Addendum 4 - VI Mitigation Work Plan

South Dayton Dump and Landfill Site
Moraine, Ohio

Submitted to:
US EPA Region 5
Emergency Response Branch
Cincinnati, OH
OSC Steve Renninger

figure 4.3

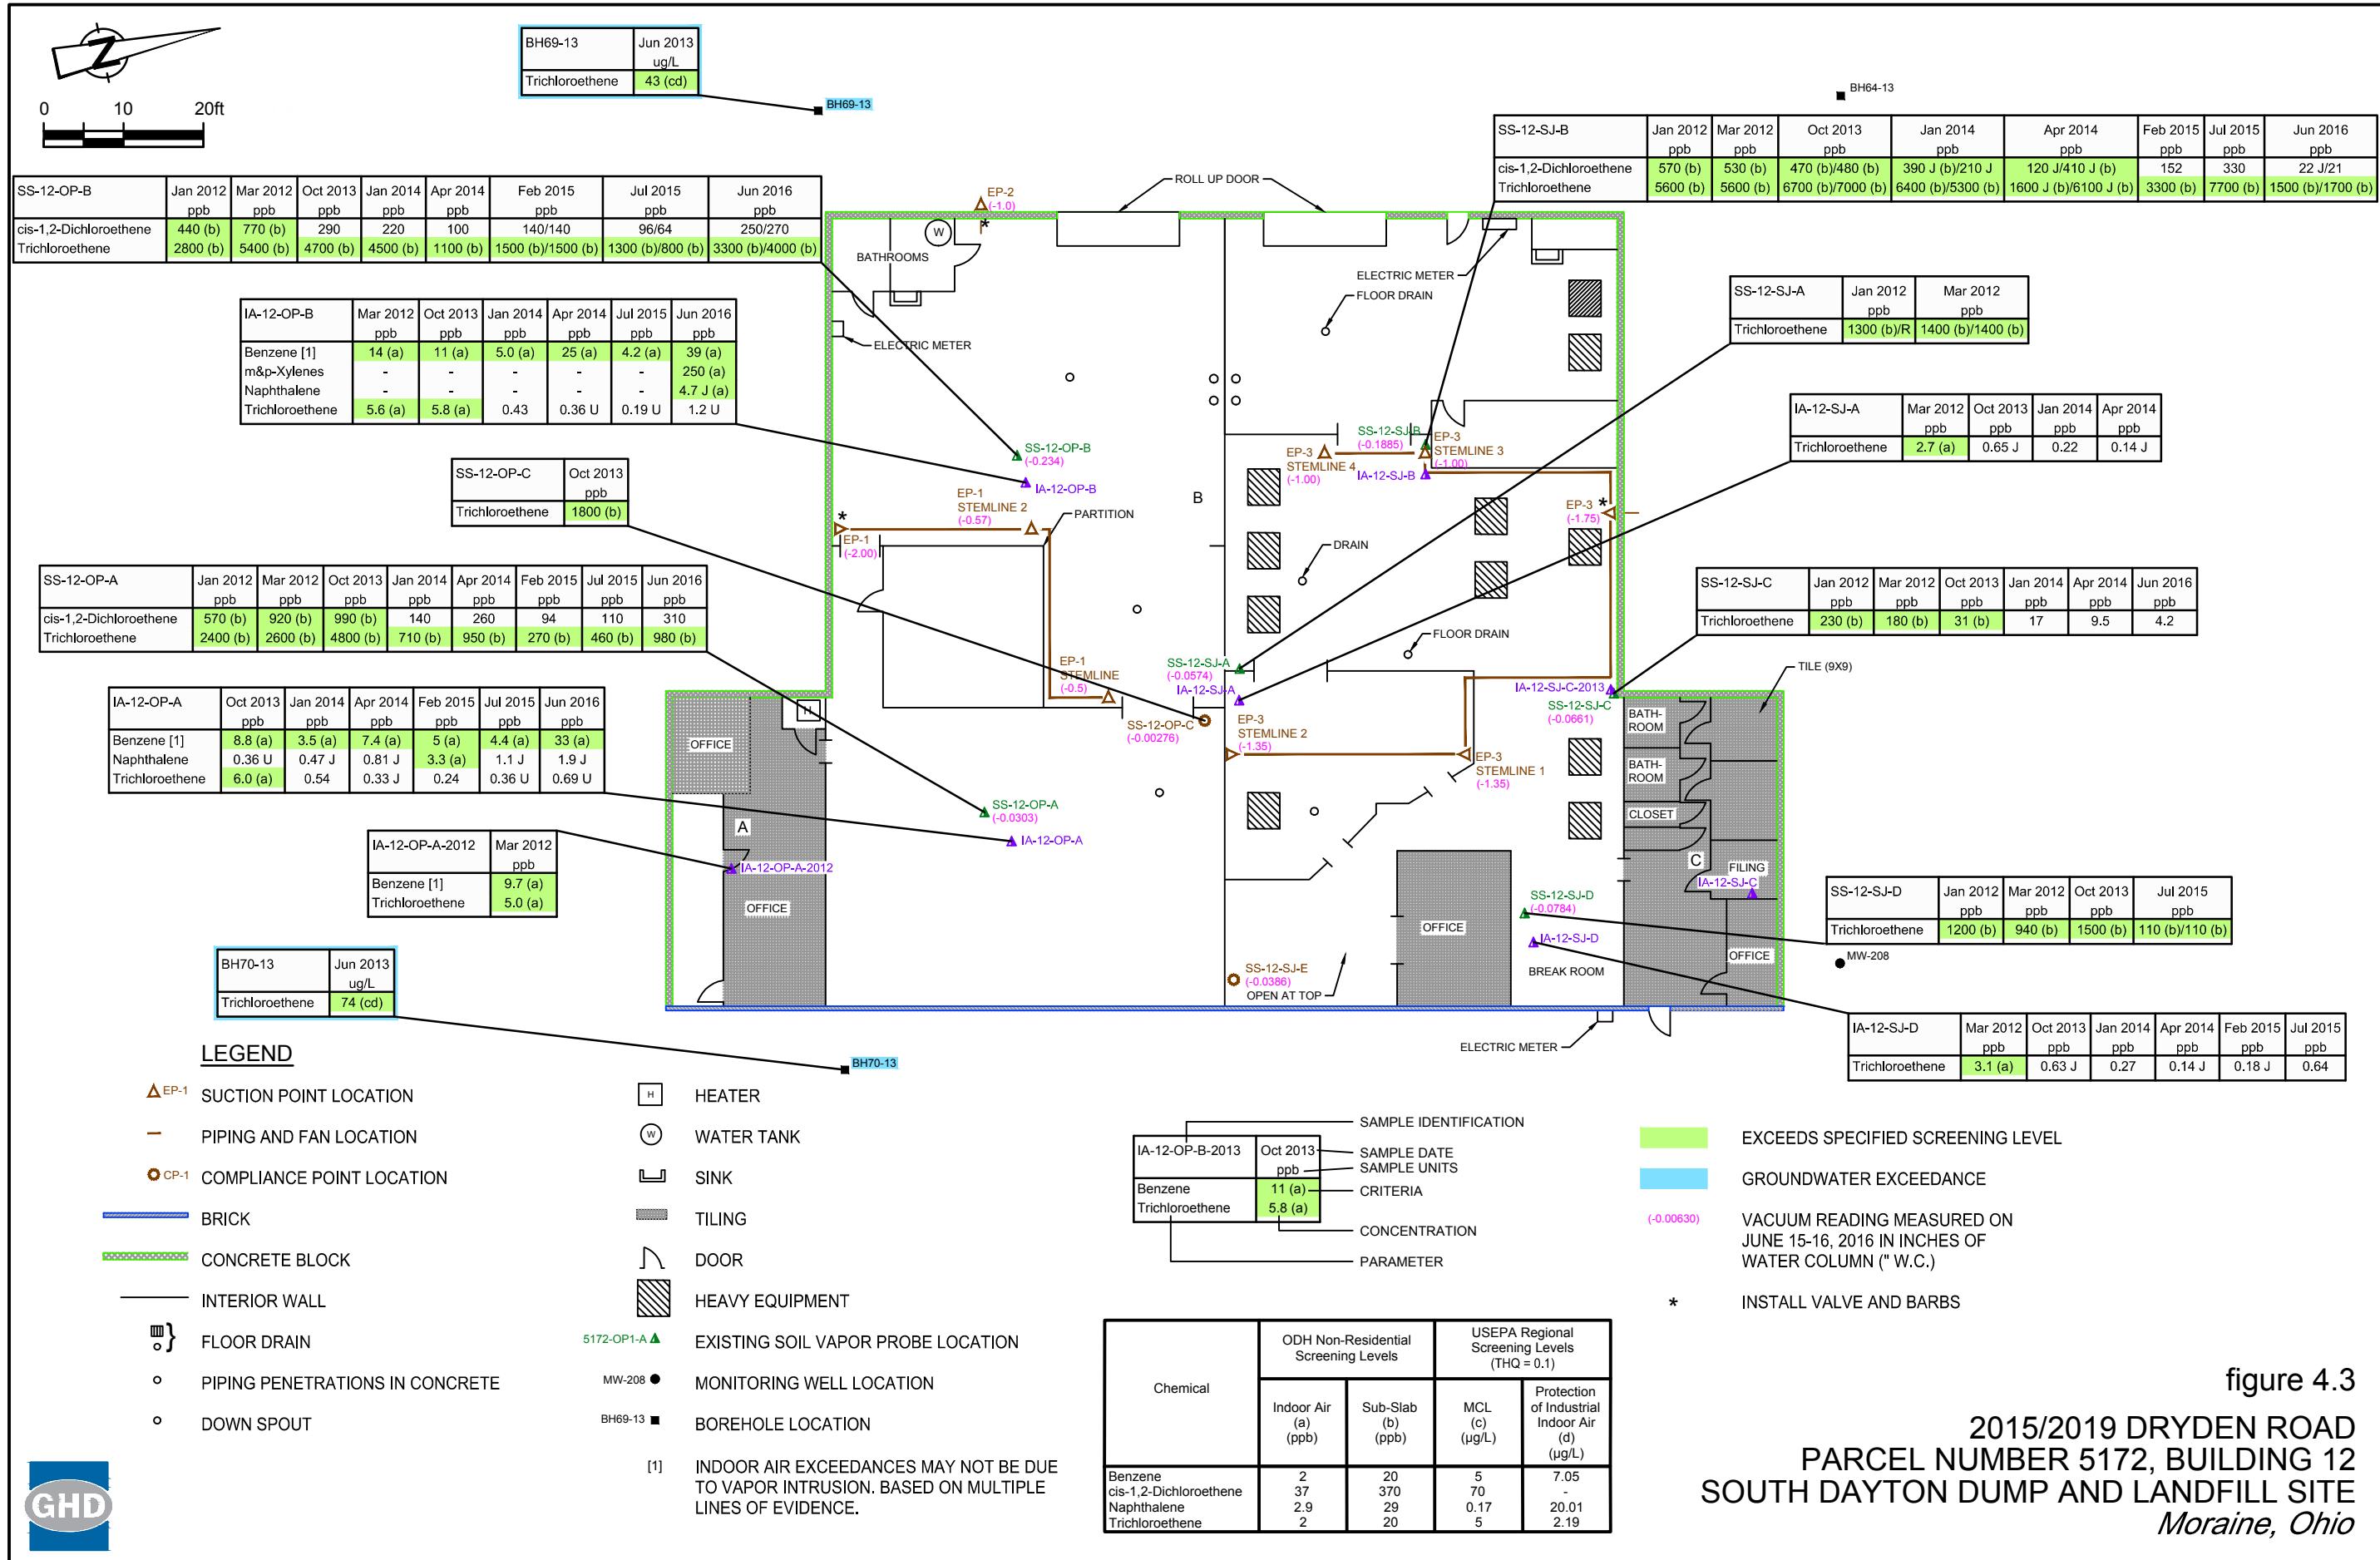
Although the SS concentrations in Buildings 8, 9, and 12 remain greater than ODH screening levels, the concentrations have decreased significantly in comparison to the pre-mitigation results, with the exception of Building 12 - Overstreet Painting¹(see Figures 4.1 to 4.3). On a VI conference call held

Proposed annual sampling locations for all buildings are presented in Table 1, and on Figures 4.1 to 4.7. The USEPA will have the opportunity to approve or modify the proposed locations and may elect to collect split-SS samples or to collect SS or IA samples at other locations.
